May 2022
FL921A
NHTSA #22V-153

Subject: Thomas Built Buses EFX Seat Bolts

Models Affected: Specific model years 2020-2023 Thomas Built Saf-T-Liner EFX school buses manufactured June 6, 2019, through November 30, 2021.

Fig. 6, Stepped Shim

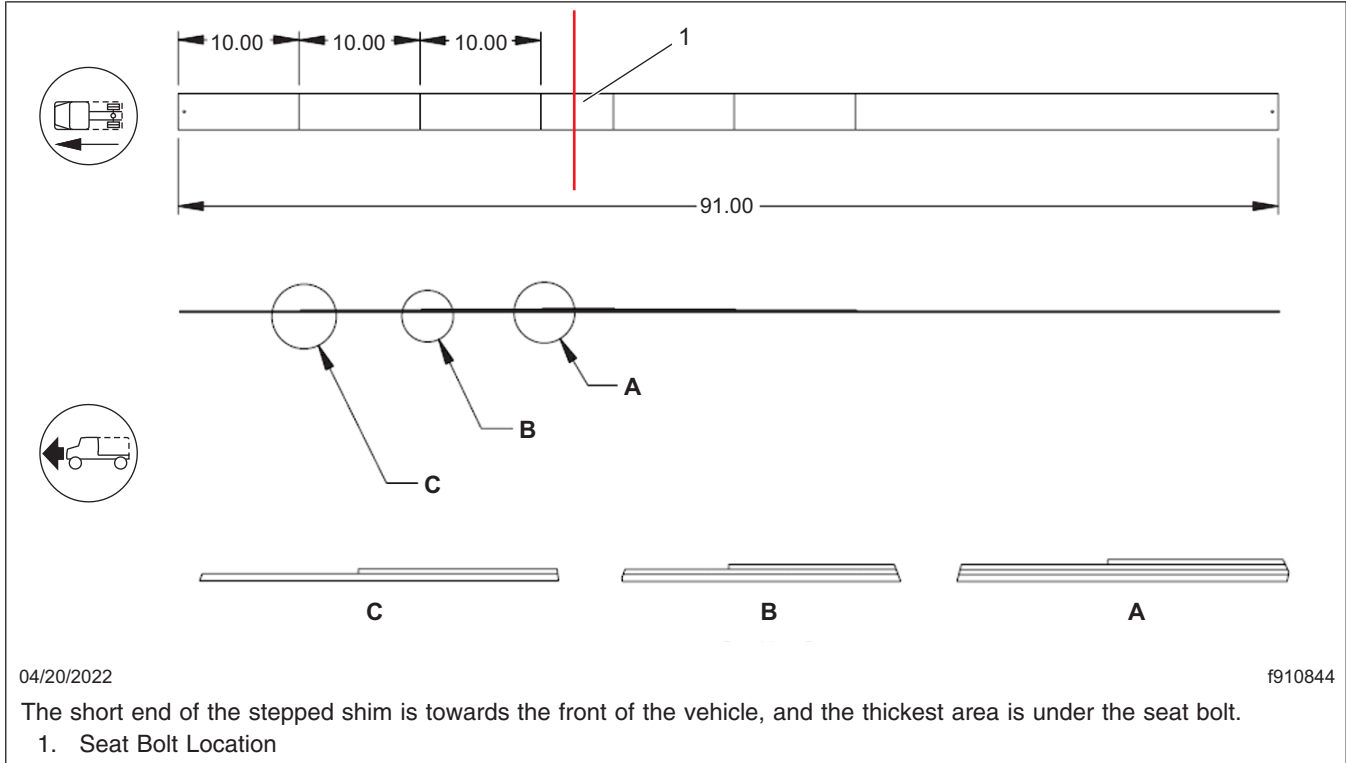
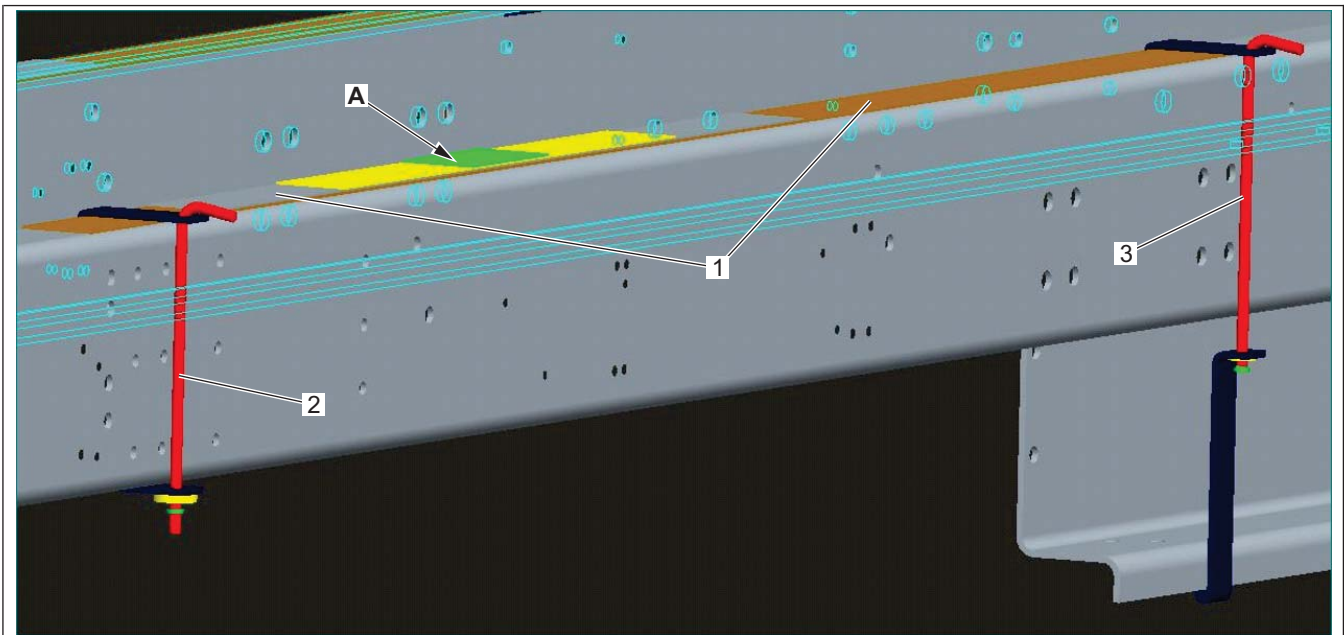
7. The shim is stepped with one side flat from end to end as, shown in Fig. 6 and Fig. 7. Make sure the shim is installed with the flat side down on the frame, as shown in Fig. 8.

Fig. 9, Center of the Shim Located Under the Seat Bolt

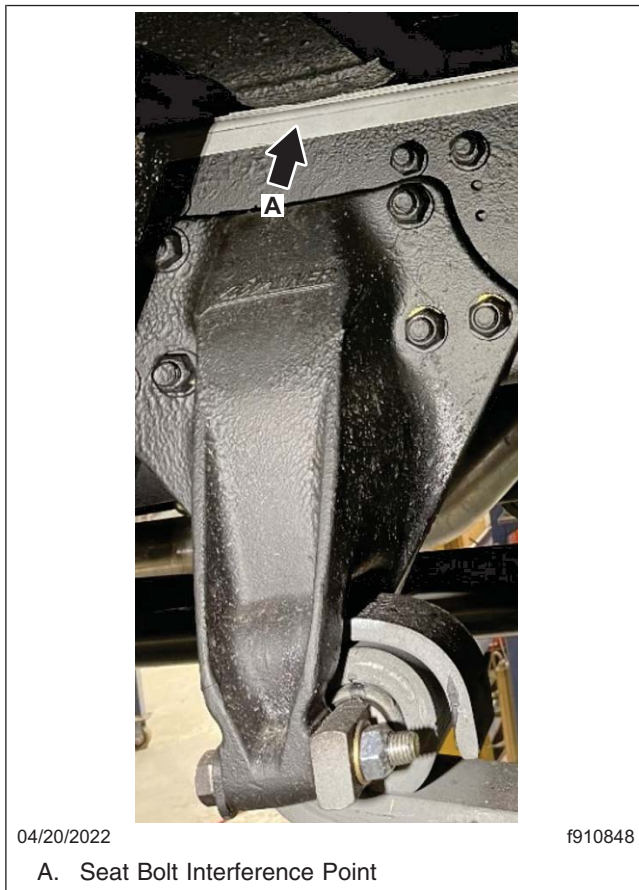
IMPORTANT: The proper location of a shim is with its short end toward the front of the vehicle, and its center directly under the seat bolt, as shown in **Fig. 9**. This is the thickest area of the shim, providing the maximum clearance between the frame and the seat bolt.

Fig. 16, Clearance Between the Seat Bolt and the Body Secured to the Chassis

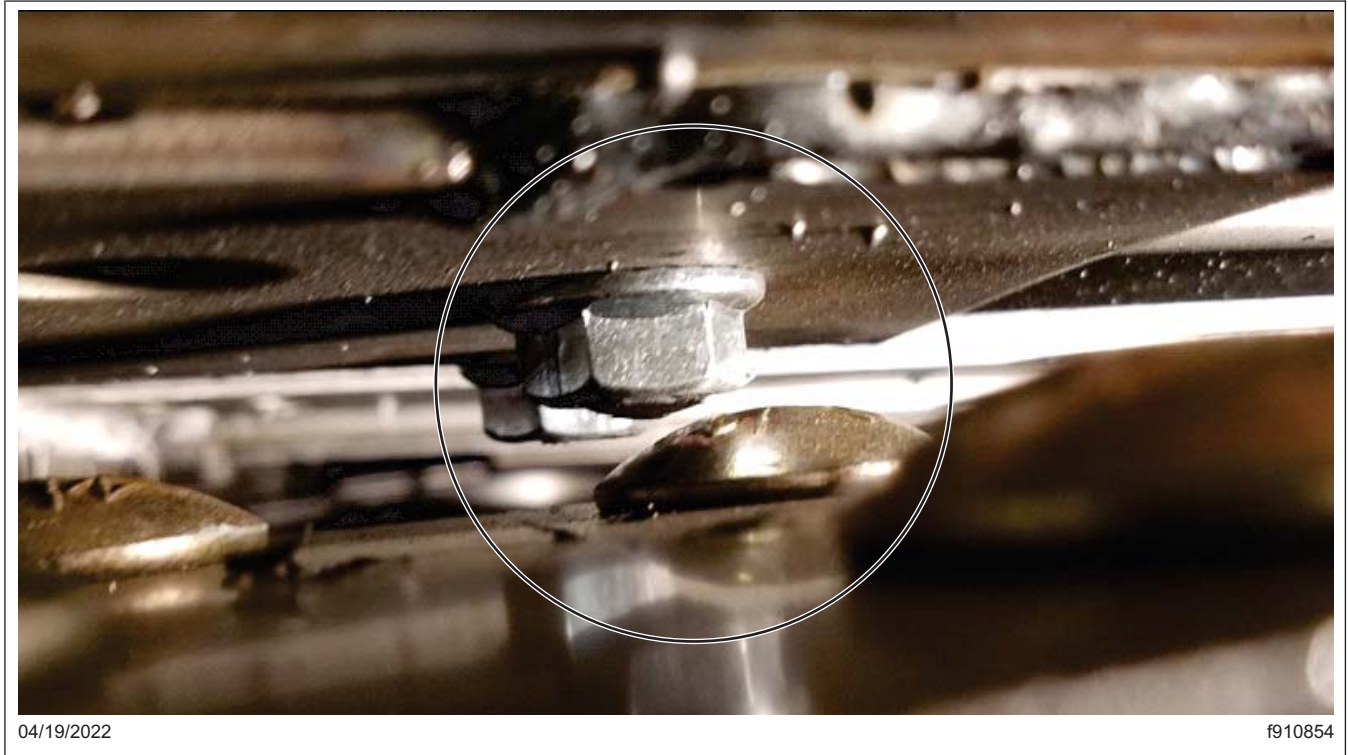
14. After the body is secured to the chassis, inspect the seat bolt for clearance, as shown in [Fig. 16](#).
